STERLING RANCH ROAD & BRIARGATE PARKWAY STORM PLANS

COUNTY OF EL PASO, STATE OF COLORADO
STORM SEWER PLANS
MARCH 2022

CD-Storm_V2.pdf Markup Summary

DP11 PROFILE
STA 10+00.00 TO 13+94.75
PUBLIC

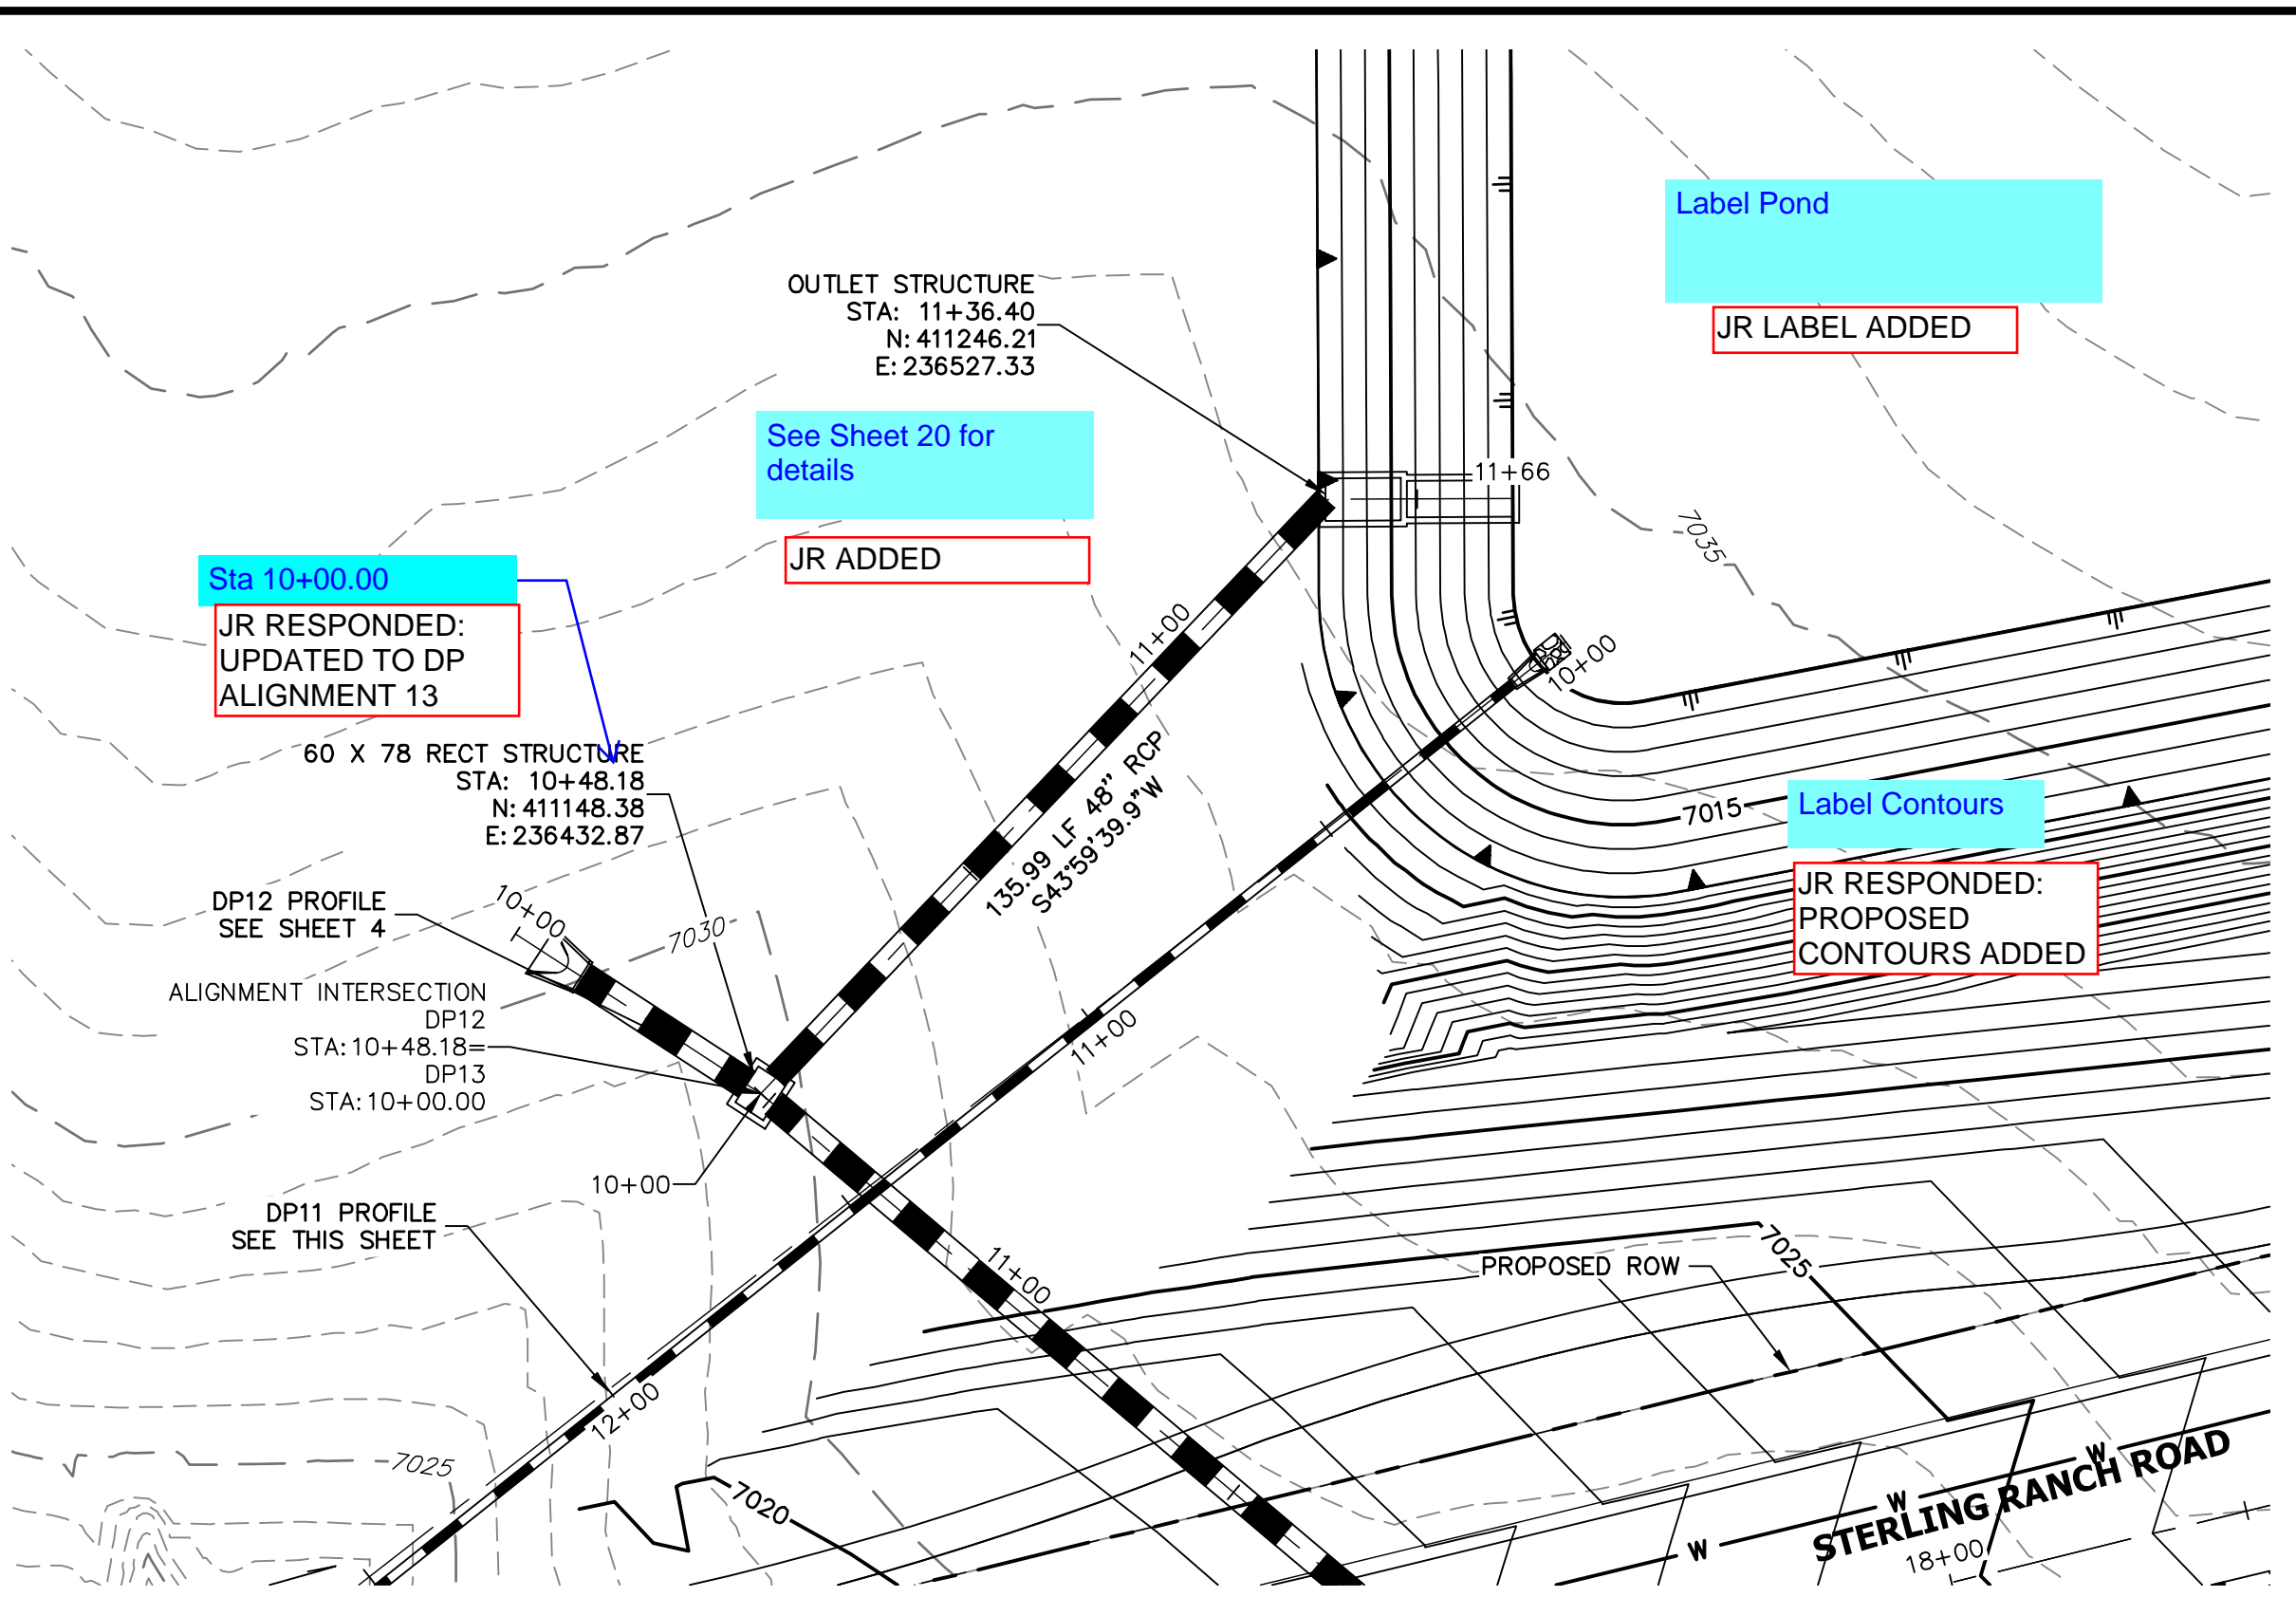
Length does not match stormcad in Dr letter.
Please revise accordingly between 2 documents

Invert does not match stormcad in Dr letter. Please
revise accordingly between 2 documents

Fix gap in proposed grading

10' Inlet per spreadsheet in Dr Letter. Please
revise accordingly between 2 documents

Grate elevation does not match with Pond spreadsheet in Dr Letter. Please revise accordingly between 2 documents

Check and revise proposed grading to match with rim elevation and cover over pipe

Label Pond

See Sheet 20 for details

Label Contours

SHEET	15	OF	23
STERLING RANCH ROAD & BRIARGATE PARKWAY STORM PLANS			
STORM SEWER PLAN & PROFILE			
H-SCALE	1"=30'	REVISION	BY DATE
V-SCALE	1"=3'		
DATE	03/22/22		
DESIGNED BY	MMC		
DRAWN BY	MMC		
CHECKED BY

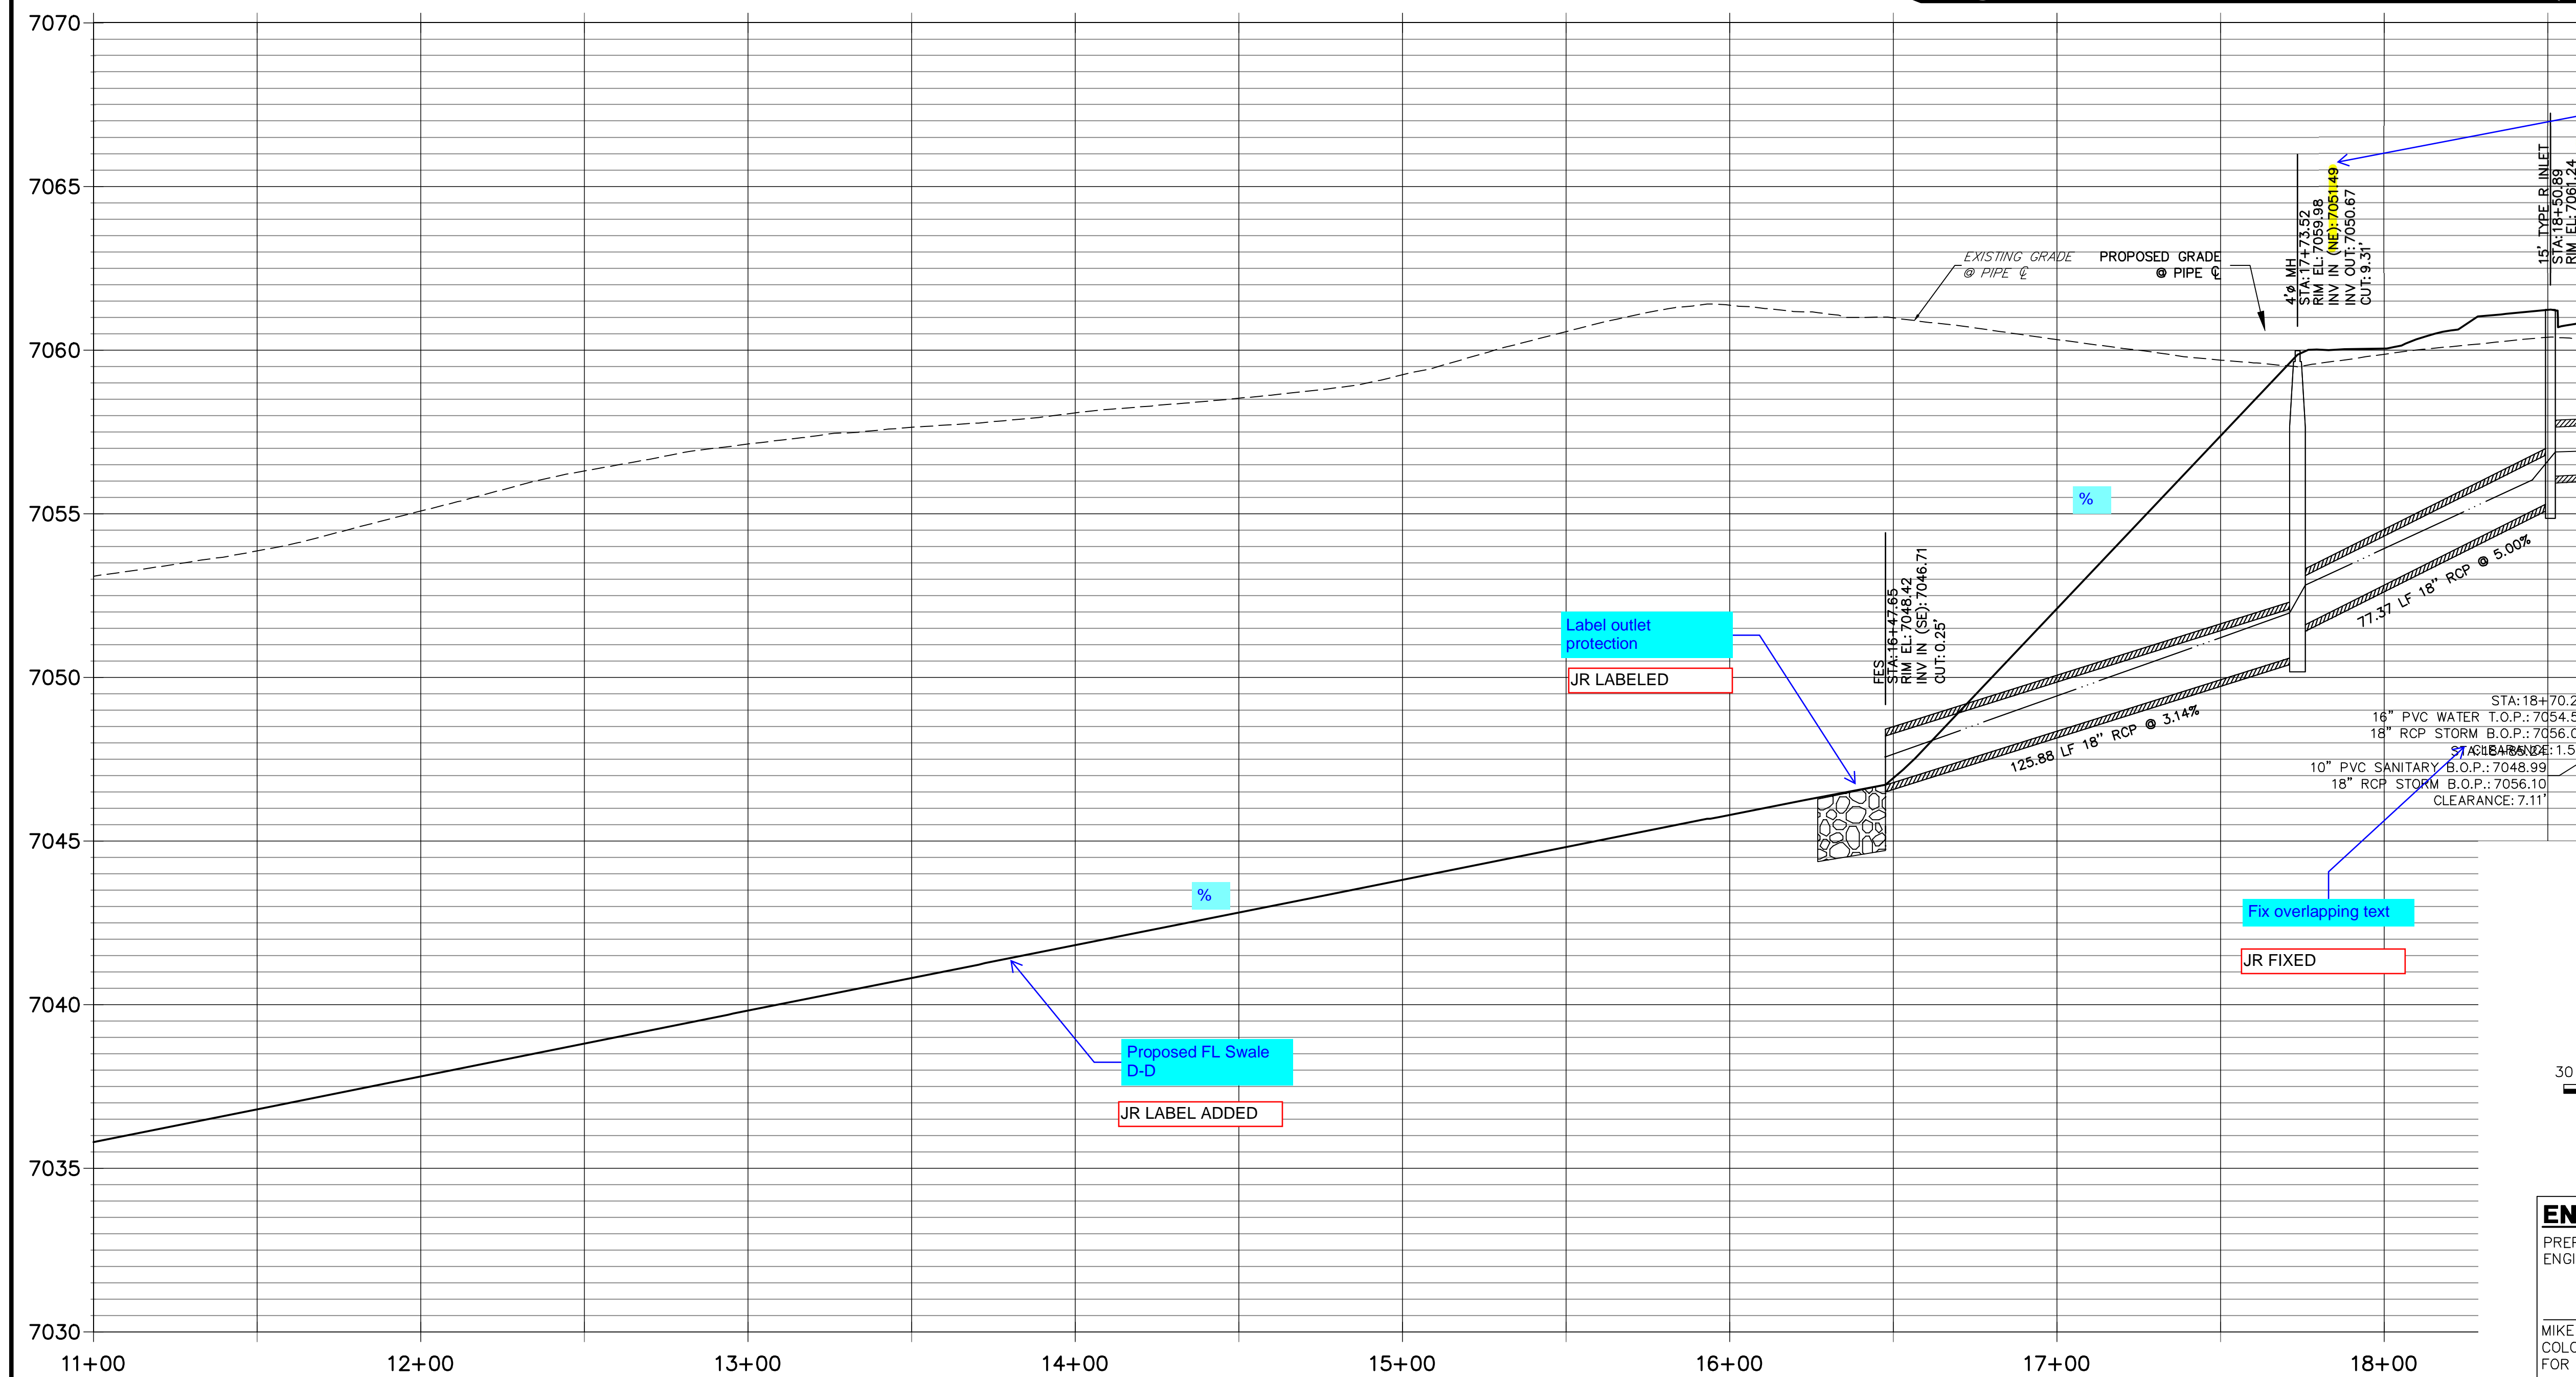
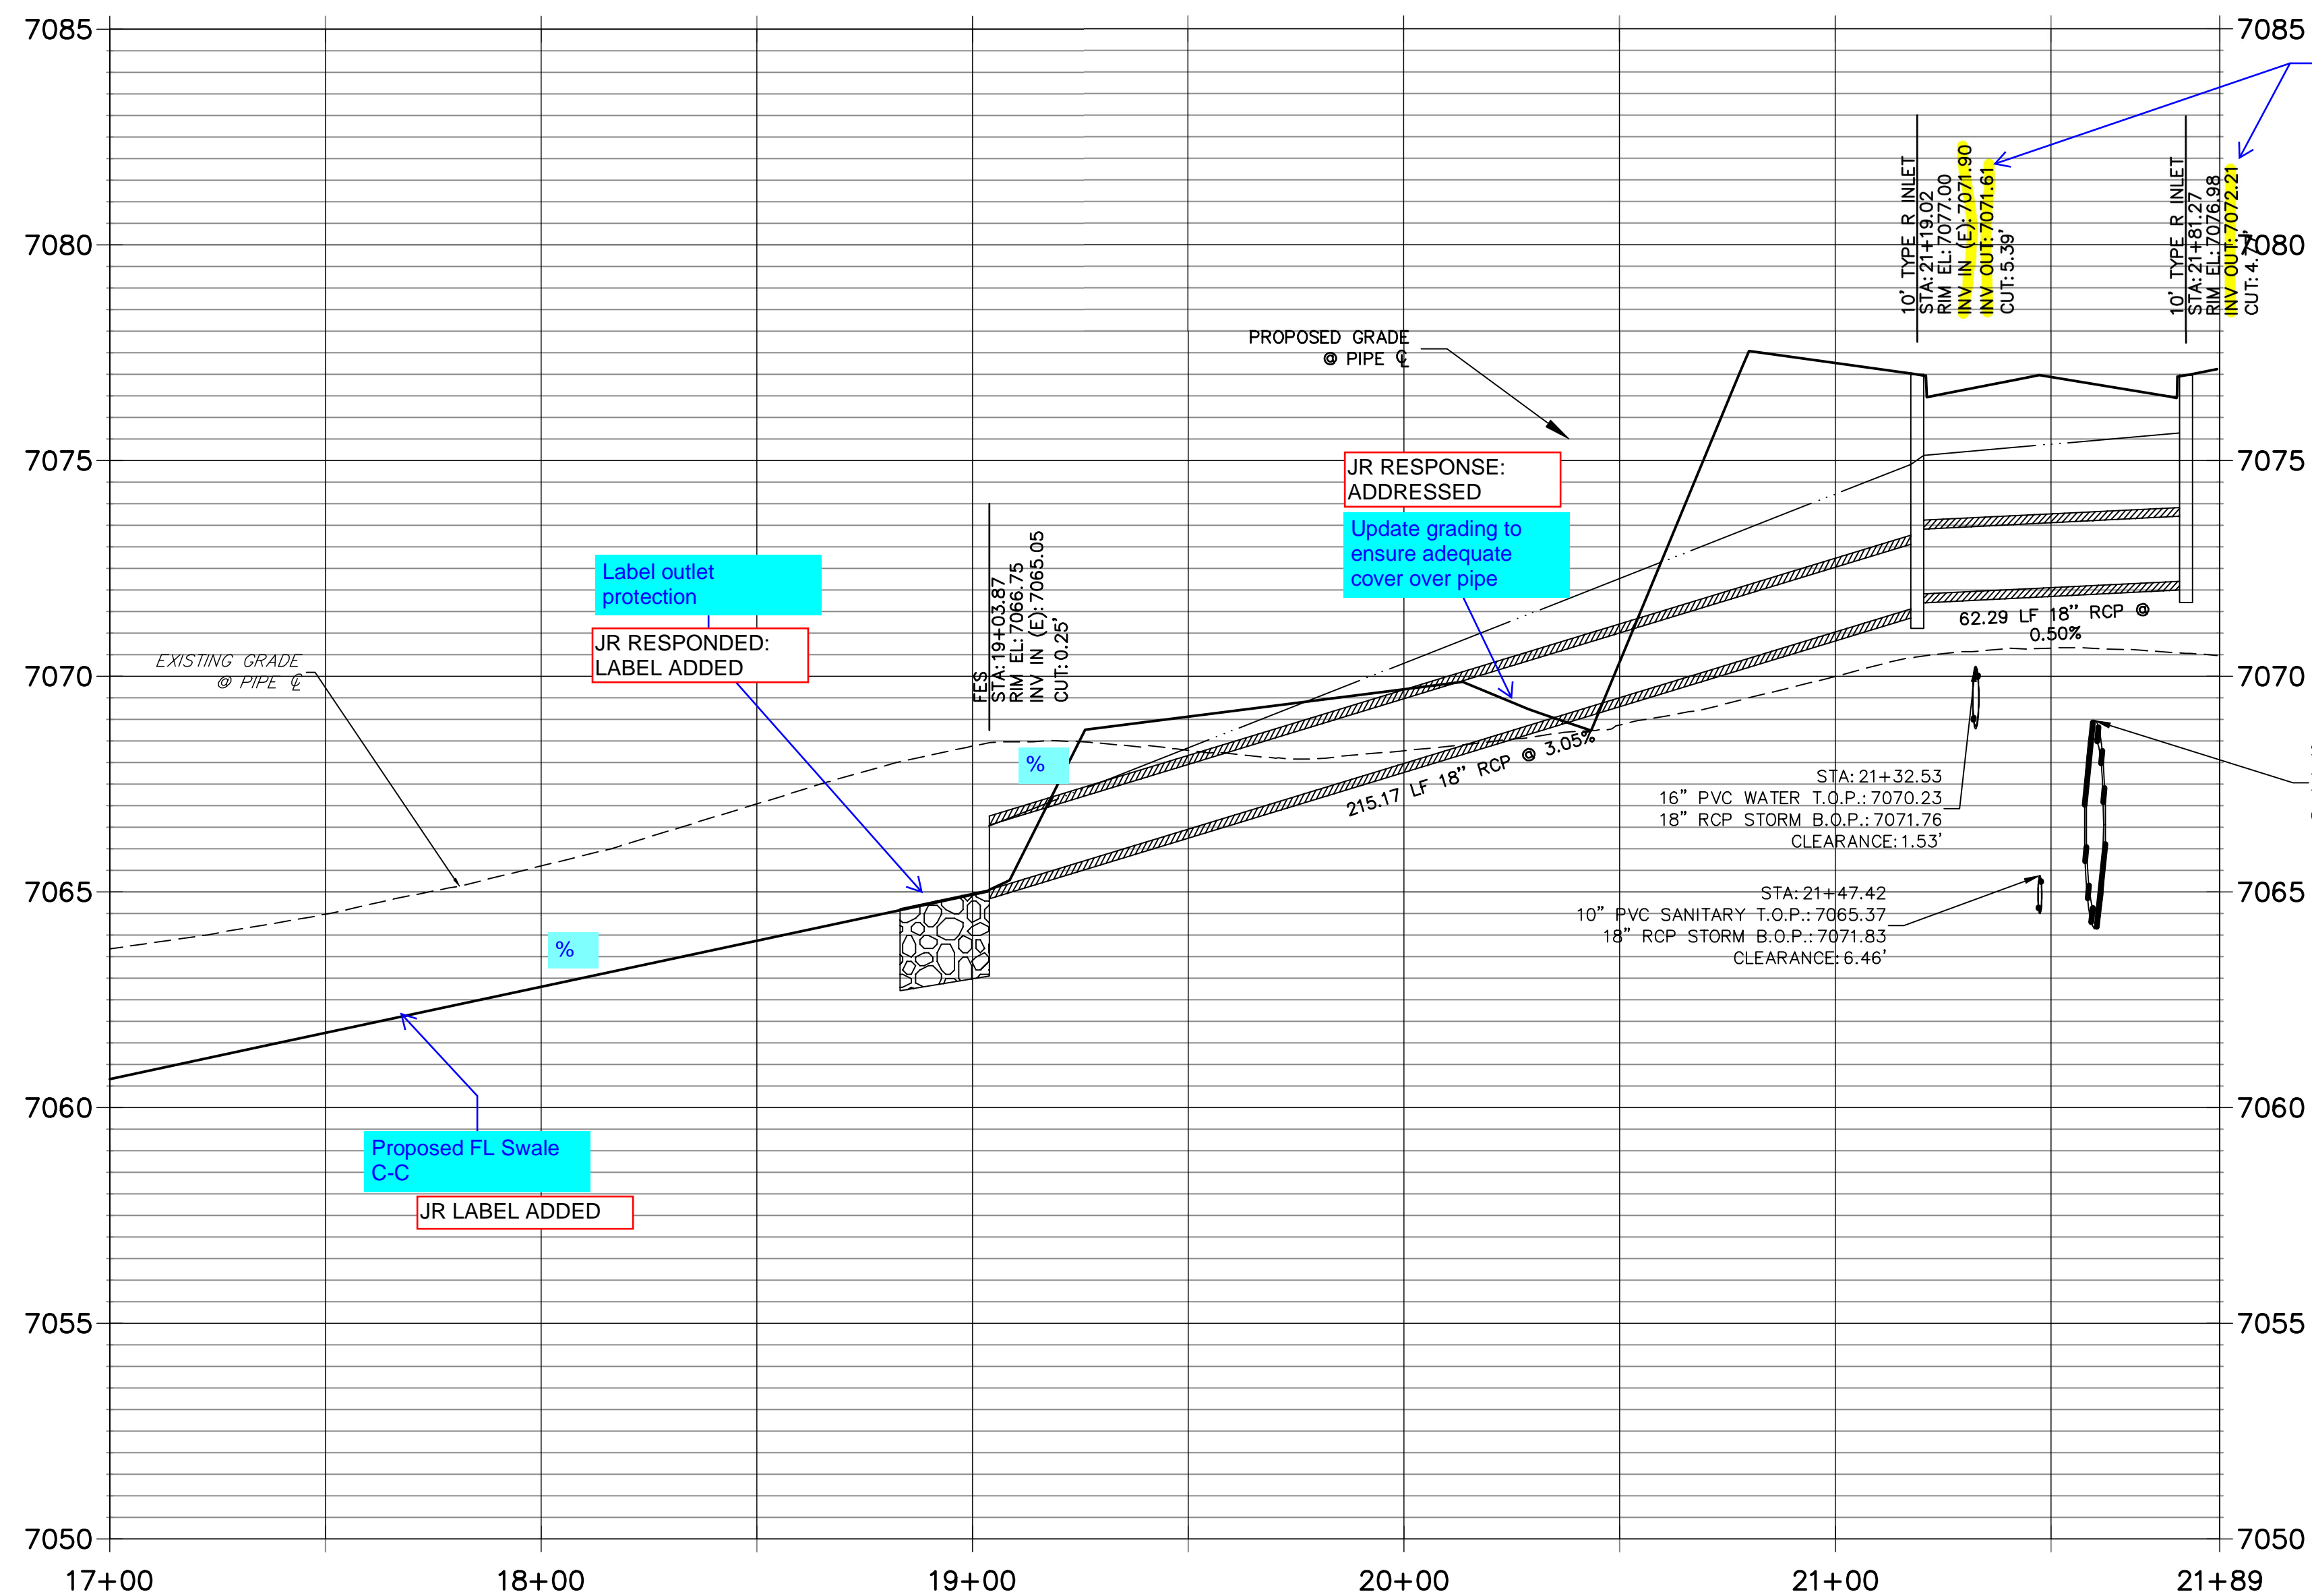
Include detail for Swale C-C section

JR RESPONDED:
SECTION ADDED
TO SHEET
